Project	IEEE 802.16 Broadband Wireless Access Working Group < http://ieee802.org/16 >	
Title	Revision of Scanning, Ranging, and Sleep Mechanism for Mobility Enhancement	
Date Submitted	2004-01-13	
Source(s)	Phillip Barber Broadband Mobile Technologies, Inc. 8302 Sebastian Inlet Frisco, Tx 75035	Voice: +1 (972) 365-6314 Fax: +1 (925) 396-0269 [mailto:pbarber@BroadbandMobileTech.com]
Re:	Response to IEEE 802.16e-03_58 (Call for Contributions on IEEE 802.16e/07r5)	
Abstract	Revision of Scanning, Ranging, and Sleep Mechanism for Mobility Enhancement	
Purpose	Stimulate discussion on a more completely defined, flexible model and mechanism for facilitating mobility functionality	
Notice	This document has been prepared to assist IEEE 802.16. It is offered as a basis for discussion and is not binding on the contributing individual(s) or organization(s). The material in this document is subject to change in form and content after further study. The contributor(s) reserve(s) the right to add, amend or withdraw material contained herein.

Revision of Scanning, Ranging, and Sleep Mechanism for Mobility Enhancement

Observations on Current IEEE 802.16e-03/07r5 Based on Criteria from Assumptions

[In Annex D.2, page 68, replace Figure D.11 with:]

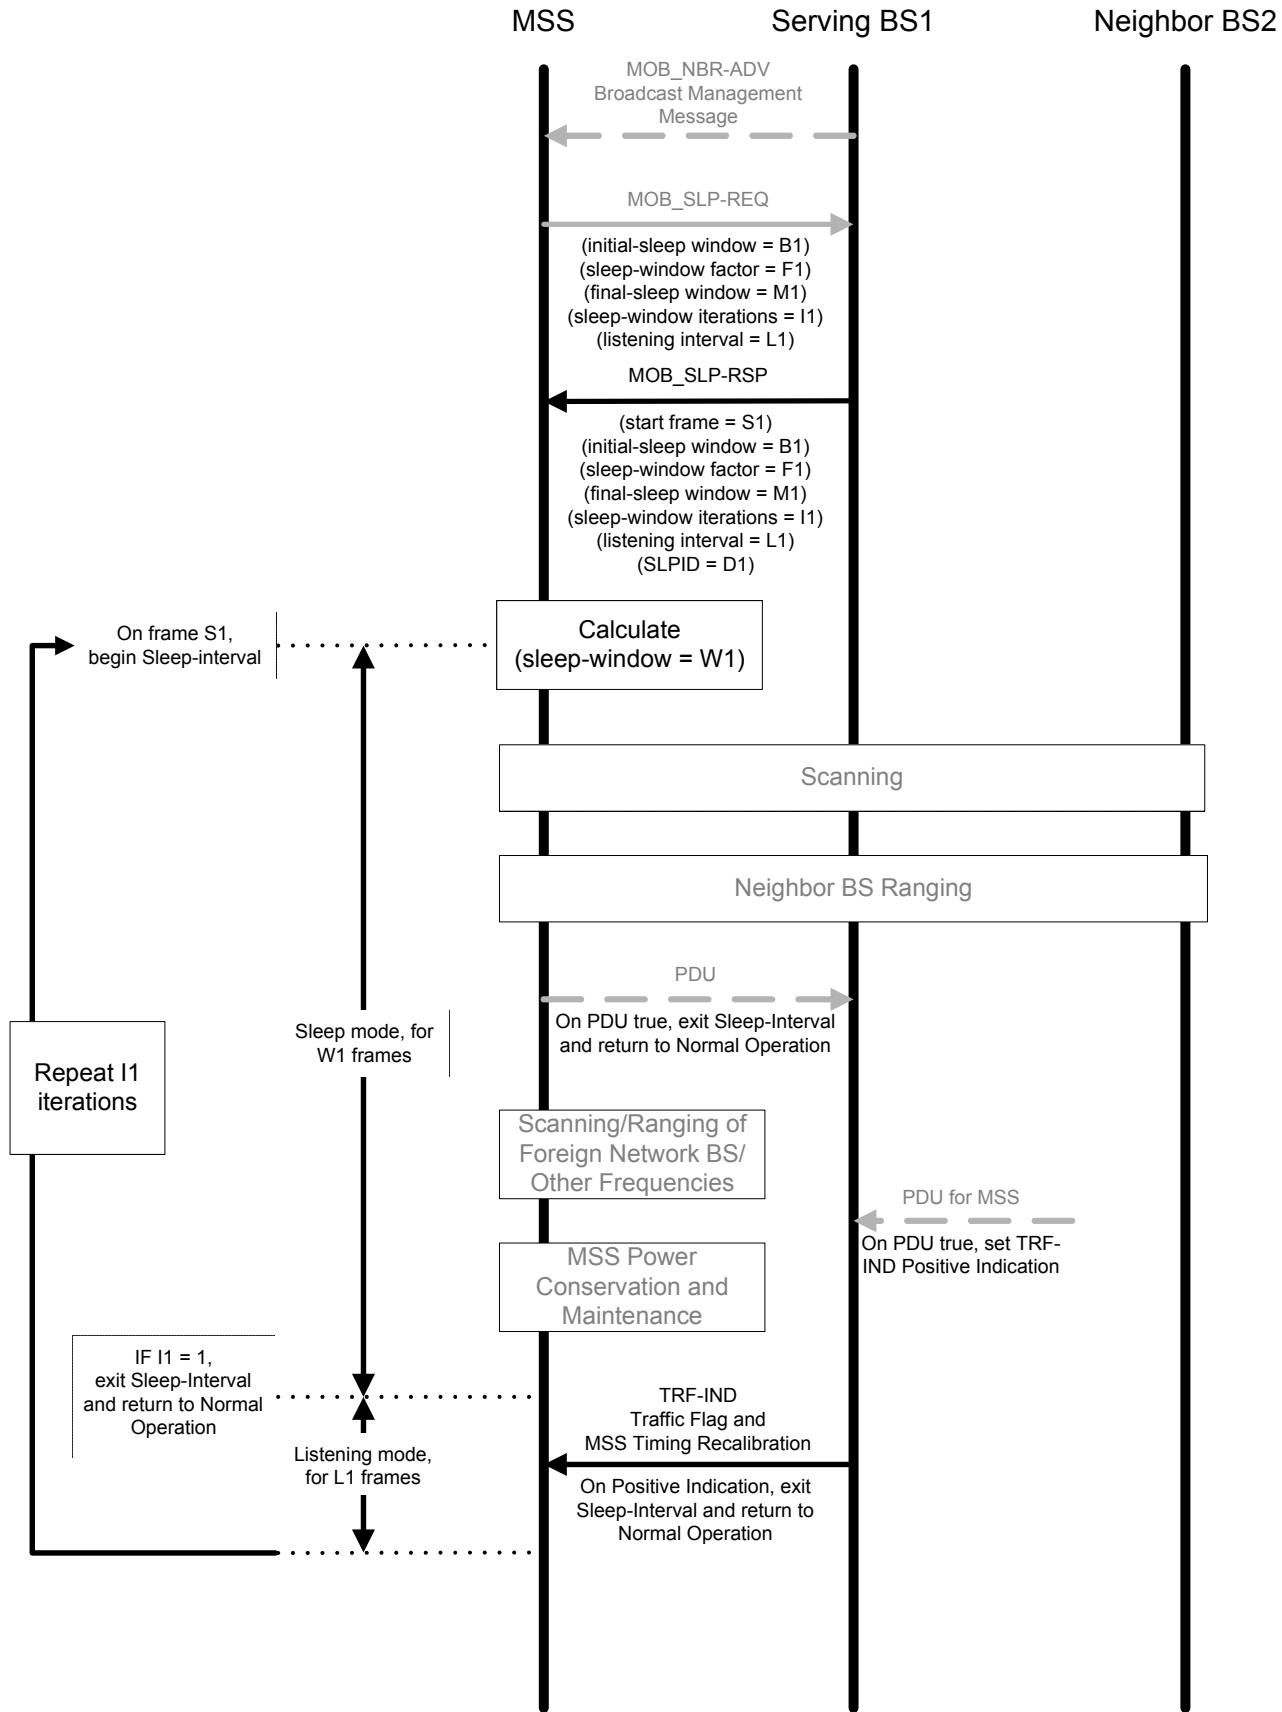
Remedy Action 12:
